Access Compliance Report

Public Rights-of-Way

(Curb Ramps)

Intersection ID: 10038888	Main Street: STINSON_CT	Cross Street: N/A	Location: E
ADA ID: E0F415DA28C5	Ramp Type: Perp	Initial Pass/Fail: Fail	Overall Compliance: No
Severity Score: 10			
Codes/Mitigation Info/Possible Solution		Field Measurements/Component Compliance

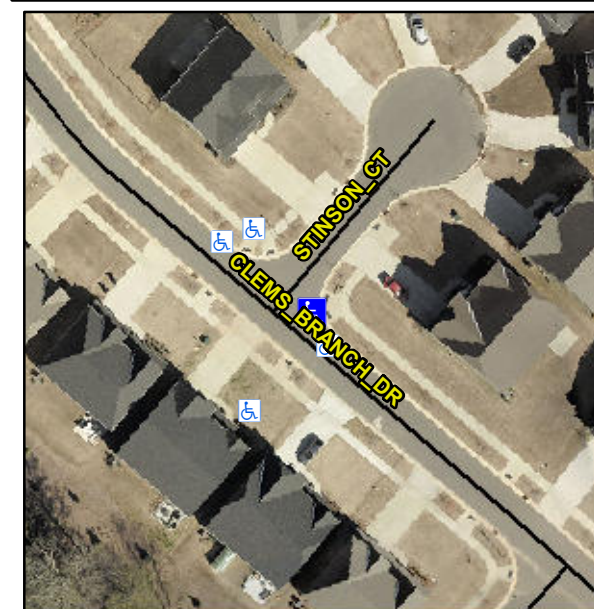
Not Found, R304.5.1, R304.5.3

Compliance	Description	Data	Compliance	Description	Data
N/A	Ramp Length (in)	96.0	Yes	Ramp Slope (%)	5.3
No	Ramp Width (in)	46.0	No	Ramp XSlope (%)	2.4
N/A	Flare Type LT	N/A	N/A	Flare Type RT	N/A
N/A	Flare Slope LT (%)	N/A	N/A	Flare Slope RT (%)	N/A
N/A	Flare Traversable LT?	N/A	N/A	Flare Traversable RT?	N/A
N/A	Landing Length (in)	N/A	N/A	DWS Provided?	N/A
N/A	Landing Width (in)	N/A	N/A	DWS Contrast?	N/A
N/A	Landing Slope (%)	N/A	N/A	DWS Length (in)	N/A
N/A	Landing X Slope (%)	N/A	N/A	DWS Full Width?	N/A
N/A	Landing Curb? (Y/N)	N/A	N/A	DWS Offset (in)	N/A
N/A	Shared Landing?	N/A			
N/A	Gutter Ponding?	N/A	N/A	Gutter Slope (%)	N/A
N/A	Gutter Lip Ht (in)	N/A	N/A	Gutter X Slope (%)	N/A
N/A	Painted X Walk1?	No	N/A	Painted X Walk2?	N/A
	X Walk 1 Direction	To NW		X Walk 2 Direction	N/A
N/A	X Walk 1 Width (in)	N/A	N/A	X Walk 2 Width (in)	N/A
	X Walk 1 Slope (%)	5.8		X Walk 2 Slope (%)	N/A
	X Walk 1 X Slope (%)	0.0		X Walk 2 X Slope (%)	N/A

Remove & Replace Entire Ramp.
